## Product Change Notice (PCN)

PCN Number: **PCN-0450899R-01**

Product(s) Affected: *SJ1-4251X Series. SJ1-42514, SJ1-42515TS & SJ1-42516*

PREVIOUS CUI DEVICES DETAIL / IMAGE	NEW CUI DEVICES DETAIL / IMAGE

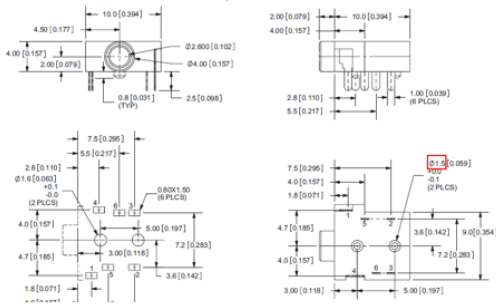
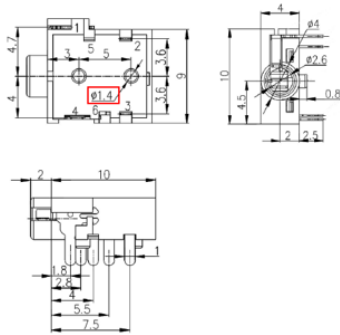
Reason(s) for Change: *Manufacturing Improvements*

Description of Change: *Locating pin difference and material change. See image Below*

<table border="1"> <thead> <tr> <th></th> <th>MATERIAL</th> <th>PLATING</th> </tr> </thead> <tbody> <tr> <td>terminal 1</td> <td>copper alloy</td> <td>gold flash</td> </tr> <tr> <td>terminal 2</td> <td>copper alloy</td> <td>gold flash</td> </tr> <tr> <td>terminal 3</td> <td>copper alloy</td> <td>gold flash</td> </tr> <tr> <td>terminal 4</td> <td>copper alloy</td> <td>gold flash</td> </tr> <tr> <td>terminal 5</td> <td>brass</td> <td>gold flash</td> </tr> <tr> <td>terminal 6</td> <td>brass</td> <td>gold flash</td> </tr> <tr> <td>plastic</td> <td>PA66</td> <td></td> </tr> </tbody> </table>		MATERIAL	PLATING	terminal 1	copper alloy	gold flash	terminal 2	copper alloy	gold flash	terminal 3	copper alloy	gold flash	terminal 4	copper alloy	gold flash	terminal 5	brass	gold flash	terminal 6	brass	gold flash	plastic	PA66		<table border="1"> <thead> <tr> <th>DESCRIPTION</th> <th>MATERIAL</th> <th>PLATING/COLOR</th> </tr> </thead> <tbody> <tr> <td>terminal 1</td> <td>phosphorous bronze t=0.25</td> <td>gold flash</td> </tr> <tr> <td>terminal 2</td> <td>phosphorous bronze t=0.20</td> <td>gold flash</td> </tr> <tr> <td>terminal 3</td> <td>phosphorous bronze t=0.20</td> <td>gold flash</td> </tr> <tr> <td>terminal 4</td> <td>phosphorous bronze t=0.25</td> <td>gold flash</td> </tr> <tr> <td>terminal 5</td> <td>phosphorous bronze t=0.20</td> <td>gold flash</td> </tr> <tr> <td>terminal 6</td> <td>phosphorous bronze t=0.20</td> <td>gold flash</td> </tr> <tr> <td>housing</td> <td>PA66 [UL94V-0]</td> <td>black</td> </tr> </tbody> </table>	DESCRIPTION	MATERIAL	PLATING/COLOR	terminal 1	phosphorous bronze t=0.25	gold flash	terminal 2	phosphorous bronze t=0.20	gold flash	terminal 3	phosphorous bronze t=0.20	gold flash	terminal 4	phosphorous bronze t=0.25	gold flash	terminal 5	phosphorous bronze t=0.20	gold flash	terminal 6	phosphorous bronze t=0.20	gold flash	housing	PA66 [UL94V-0]	black

MATERIAL	PLATING																																															
terminal 1	copper alloy	gold flash																																															
terminal 2	copper alloy	gold flash																																															
terminal 3	copper alloy	gold flash																																															
terminal 4	copper alloy	gold flash																																															
terminal 5	brass	gold flash																																															
terminal 6	brass	gold flash																																															
plastic	PA66																																																
DESCRIPTION	MATERIAL	PLATING/COLOR																																															
terminal 1	phosphorous bronze t=0.25	gold flash																																															
terminal 2	phosphorous bronze t=0.20	gold flash																																															
terminal 3	phosphorous bronze t=0.20	gold flash

terminal 4	phosphorous bronze t=0.25	gold flash																																															
terminal 5	phosphorous bronze t=0.20	gold flash																																															
terminal 6	phosphorous bronze t=0.20	gold flash																																															
housing	PA66 [UL94V-0]	black
